CITIZENS FOR RESPONSIBLE DEVELOPMENT

RESPONSE TO VALOR DEVELOPMENT'S DESIGN REVIEW APPLICATION ZC CASE 16-23

January 7, 2019

AU buses idling on 48th Street and blocking entrance to alley 16

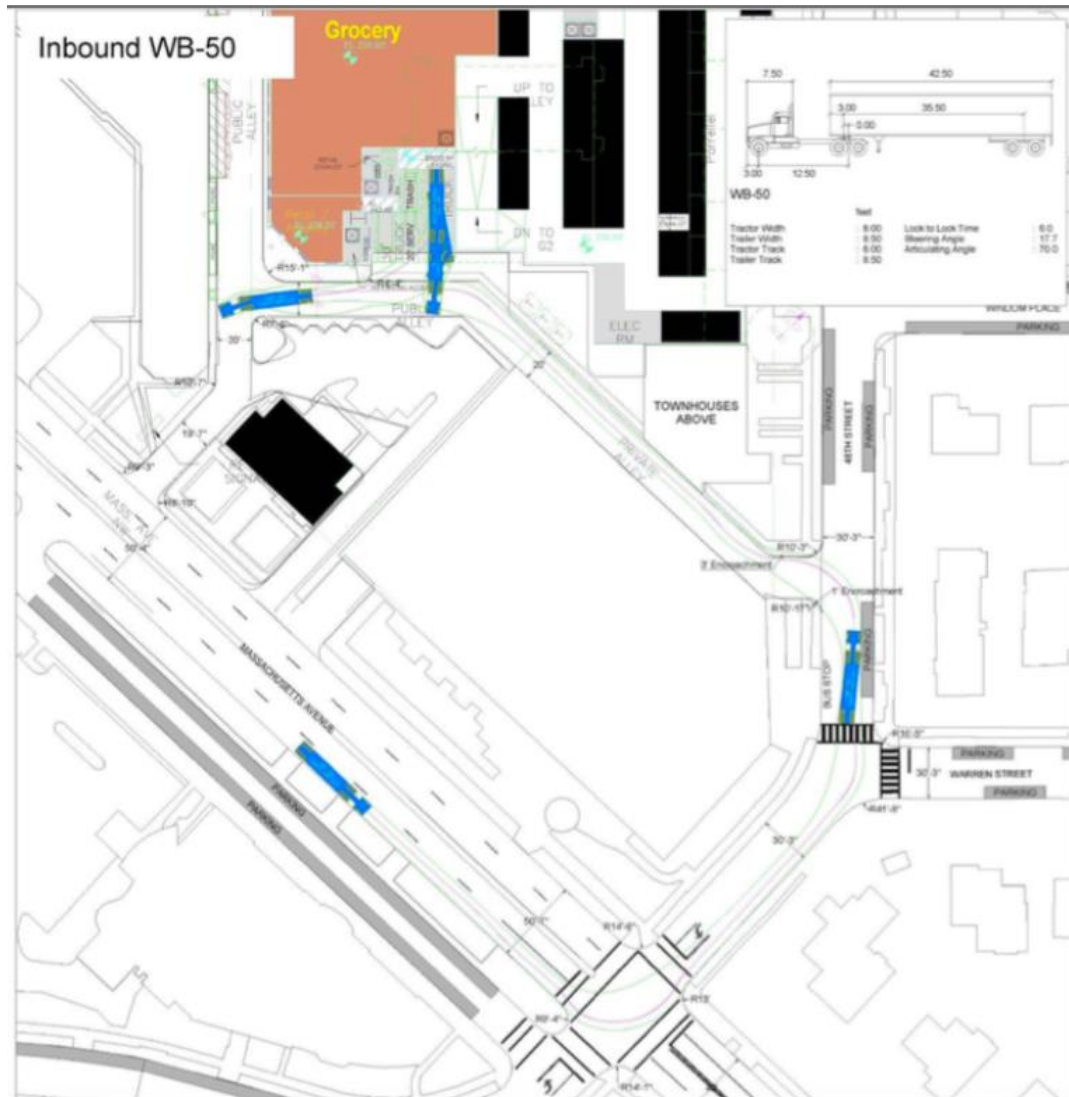
- The volume of traffic in the alleys will reach levels of the nearby city streets.
- Most cars and trucks will use E/W alley; volume will be 342 vehicles from 4 to 6 pm weekdays.
- One-third of the sidewalk along this alley is interrupted by garage and loading dock entrances.
- AU buses load near the entrance to this alley.

Viewshed diagram - "CL07 Alley View"

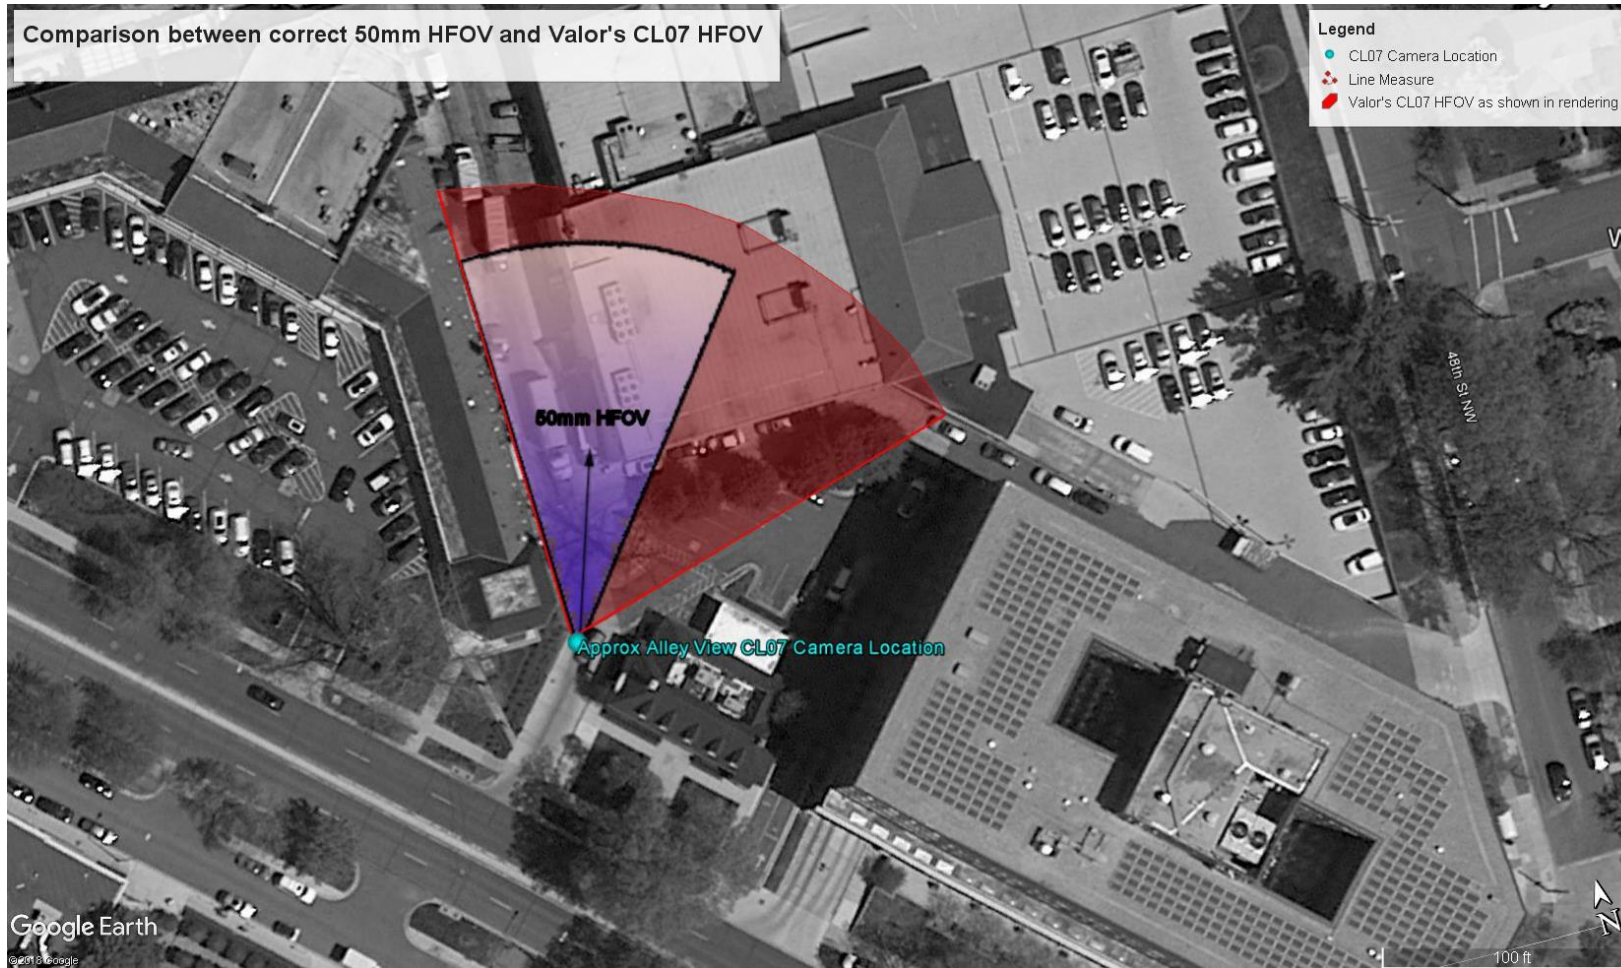
This graphic compares a true 50mm's horizontal field-of-view (Blue HFOV)(39.6°) with the actual Red HFOV portrayed in Valor's CL07 rendering. Note the dramatic difference between the two. While the rendering is labeled as a 50mm, it is clearly much wider. It is likely a 24mm lens. Using a wide-angle lens inherently reduces the visual impact of the proposed development by shrinking the building.
